**RE: Kassam Legacy – 110 Gold
Grading and Drainage Plan
Engineer's Stamp Date: 03/12/20
Hydrology File: K14D120**

Based upon the information provided in your submittal received 03/13/2020, the Grading & Drainage Plan is approved for Building Permit.

DRAINAGE AND TRANSPORTATION INFORMATION SHEET (REV 11/2018)

Project Title: Kassam Legacy 110 Gold **Building Permit #:** _____ **Hydrology File #:** K140120
DRB#: _____ **EPC#:** _____ **Work Order#:** _____
Legal Description: Tract A-2, Block B, Union Depot Frontage Addition.
City Address: 110 Gold Avenue SE, Albuquerque NM 87111

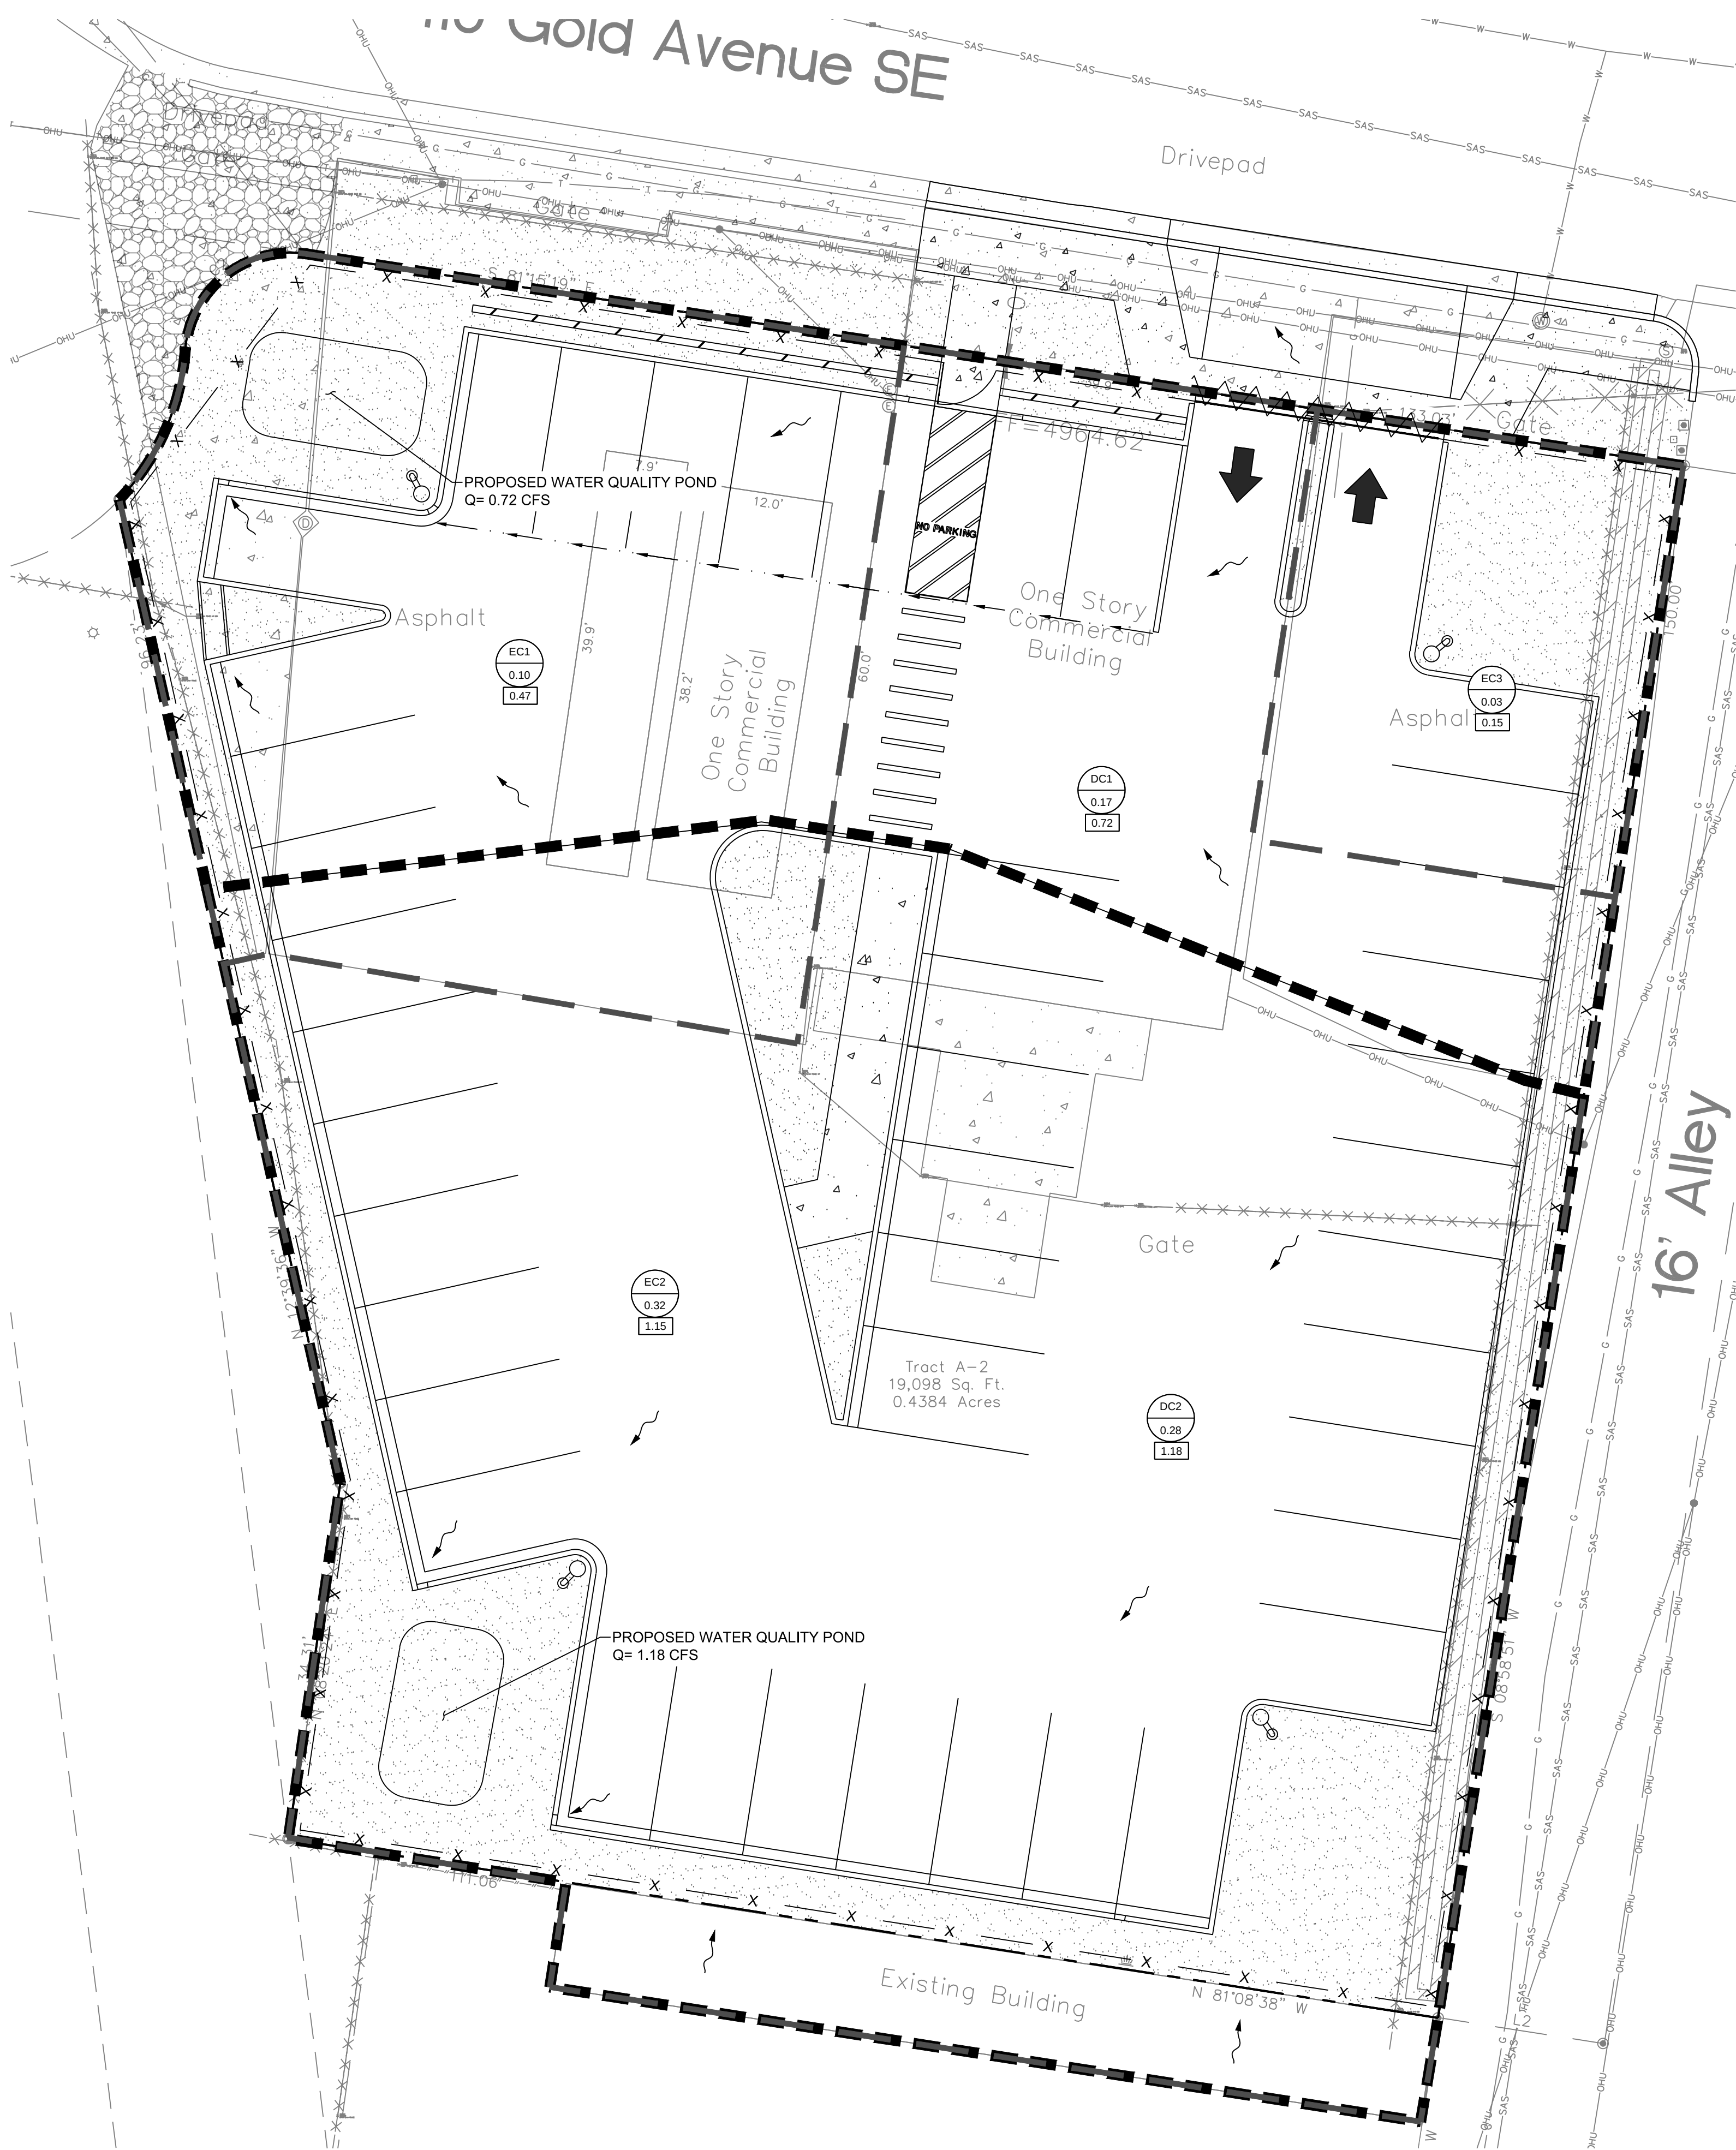
Please attach a copy of this approved plan in the construction sets for Building Permit processing along with a copy of this letter. Prior to approval in support of Permanent Release of Occupancy by Hydrology, Engineer Certification per the DPM checklist will be required.
